RE: ZONE-22-0020 – Response to City/Public Comments

On behalf of the City of Colorado Springs Department of Public Works, Engineering Division, I respectfully offer the following responses to comments provided pursuant to the City's intra-agency review and public comment period for the proposed ZONE-22-0020:

# EXHIBIT C

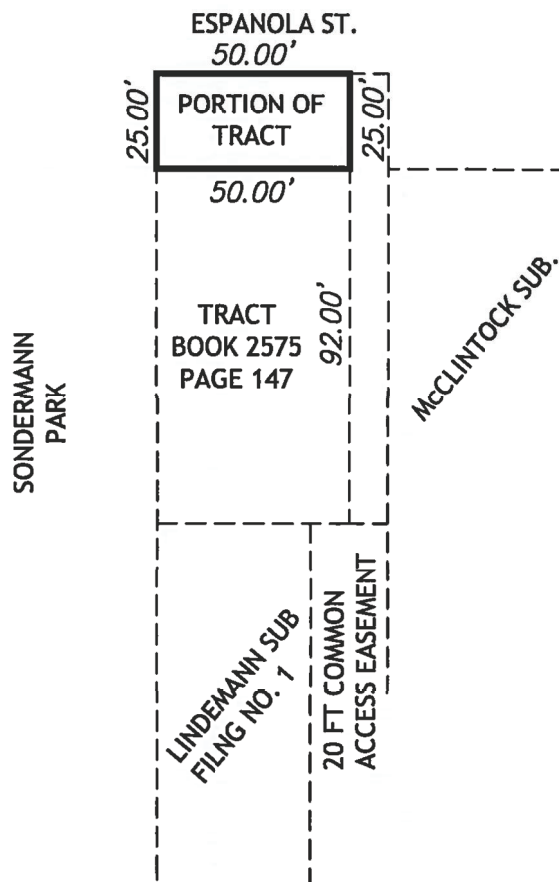
5. *What are the exact boundary lines of the land that will become private property? The project map attached to File ZONE-22-0020 shows only the footprint of the existing building but not the outlines of the new land parcel.*

The City's Engineering Division respects and acknowledges the importance of public spaces and access to nature within our City. The City's 1,249-square foot (+/-) property proposed for re-zone/exchange will be exchanged for 1,250-square feet (+/-) of private property to be utilized as public right of way (see **Exhibit "C"** attached). The proposed re-zone/exchange will contribute to no more development than the recipient is allowed, directly adjacent to Sonderman Park, prior to the exchange. It provides the recipient with the same net area of private property as before the exchange and provides the City with title to right of way for Espanola Street.

The boundaries of the City property proposed for re-zone/exchange are depicted on Exhibit B attached. The total area of the City property proposed for re-zone/exchange is 1,249-square feet (+/-) lying, generally, south of the intersection of W. Espanola Street and 7<sup>th</sup> Street. The east boundary of the City property proposed for re-zone/exchange is adjacent to private property and is proposed to be exchanged for 1,250 square feet (+/-) of public right of way for Espanola Street from the adjacent property owner (See **Exhibit "C"** attached).
